BRUNSWICK STEAM ELECTRIC PLANT, UNIT NOS. 1 AND 2
DOCKET NOS. 50-325 AND 50-324/LICENSE NOS. DPR-71 AND DPR-62
REVISIONS TO PLANT EMERGENCY PROCEDURES

Summary of Revisions

OPEP-02.1.1

OPEP-02.6

ATTACHMENT 1
Page 1 of 1
Site Emergency Coordinator Actions Flow Chart

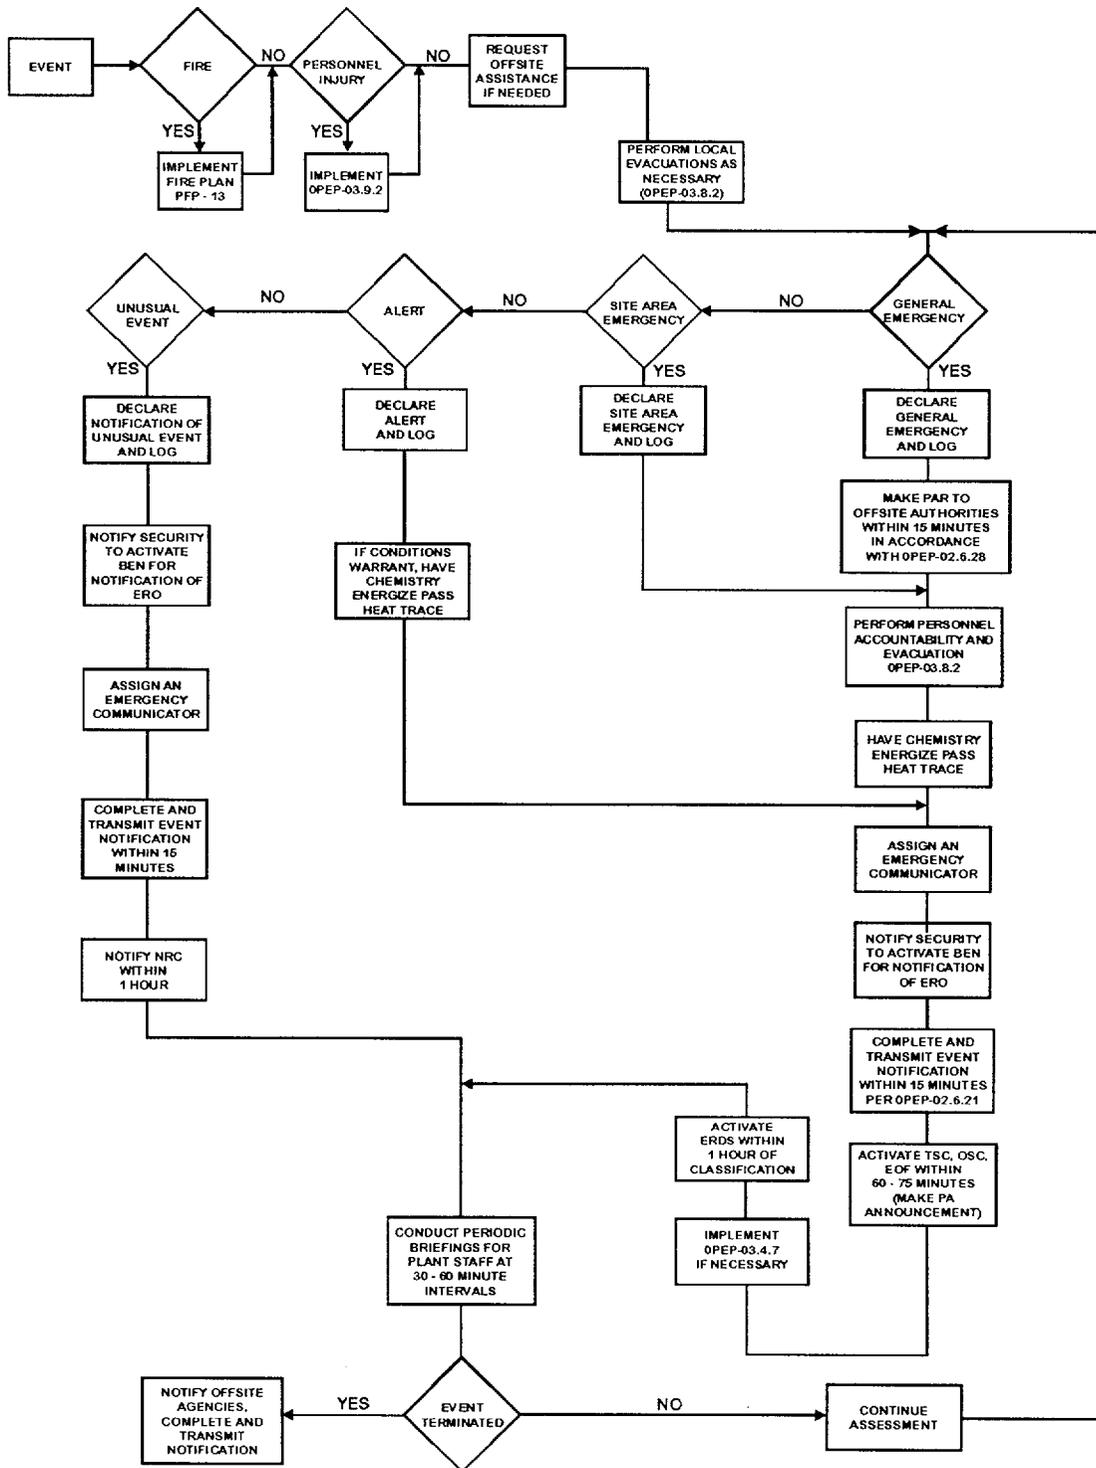
- A. OPEP-02.1.1, "Emergency Control - Notification of Unusual Event, Alert, Site Area Emergency, and General Emergency," Revision 5:
1. Revised Attachment 1, "Site Emergency Coordinator Actions Flow Chart," to remove the Emergency Response Data System (ERDS) activation requirement from the Unusual Event path;

- Corrected the flow chart in Attachment 1, removing the activation of ERDS from the Unusual Event path.
- Added new Section 7.0, Records as an enhancement.
- Added Unusual Event to Attachment 3, Section A, SEC Turnover/Briefing Worksheet.
